DEVIATION REQUEST AND DECISION FORM

Project Name :	Crossroads North
Schedule No.(s) :	5408001008, 5408001029, 5408001032, 5408001033, 5408001034, 5408001041, 5408001042, 5408001050, 5408001051, 5408001052
Legal Description :	LOTS 12, 13, 14, 15, 16 AND 18, HILLCREST ACRES, ACCORDING TO THE PLAT THEREOF RECORDED MAY 12, 1960 AT RECEPTION NO. 153860, EXCEPT THAT PORTION ACQUIRED BY THE DEPARTMENT OF TRANSPORTATION, STATE OF COLORADO AS DESCRIBED IN RULE AND ORDER RECORDED APRIL 28, 2004 UNDER RECEPTION NO. 204068322, AND EXCEPT THOSE PORTIONS CONVEYED TO EL PASO COUNTY BY AND THROUGH THE BOARD OF COUNTY COMMISSIONERS OF EL PASO COUNTY, COLORADO BY SPECIAL WARRANTY DEED RECORDED DECEMBER 17, 2014 AT RECEPTION NO. 214116021 AND RECORDED DECEMBER 17, 2014 AT RECEPTION NO. 214116022, COUNTY OF EL PASO, STATE OF COLORADO. LOT 17, HILLCREST ACRES, COUNTY OF EL PASO, STATE OF COLORADO, EXCEPT THAT PORTION CONVEYED TO EL PASO COUNTY BY AND THROUGH THE BOARD OF COUNTY COMMISSIONERS OF EL PASO COUNTY, COLORADO BY SPECIAL WARRANTY DEED RECORDED DECEMBER 30, 2014 AT RECEPTION NO. 214119767. LOT 19, HILLCREST ACRES, COUNTY OF EL PASO, STATE OF COLORADO, AS AMENDED BY SURVEYOR'S STATEMENT RECORDE

SCALE: NOT TO SCALE

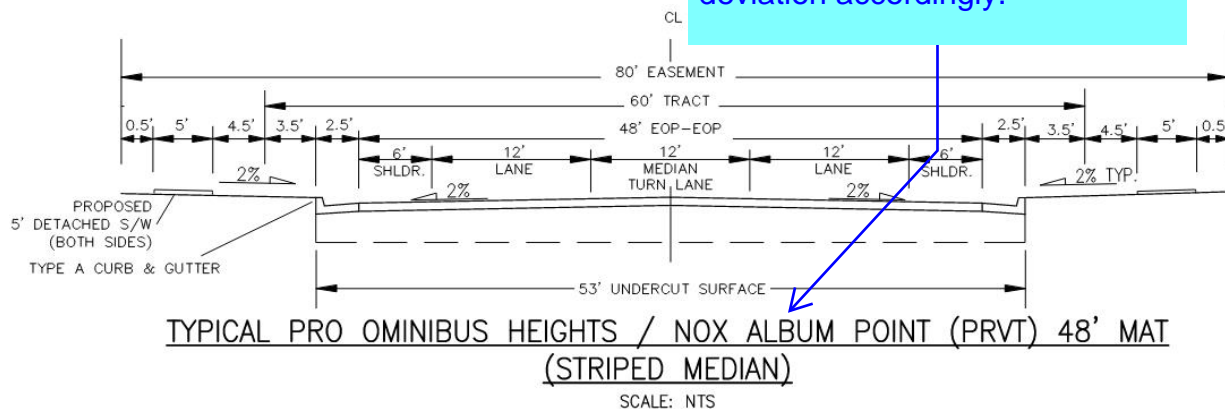
565' for non-residential collector

The preliminary plan sheets show a 36' paved width for Nox Album Pt. Coordinate and revise the deviation accordingly.
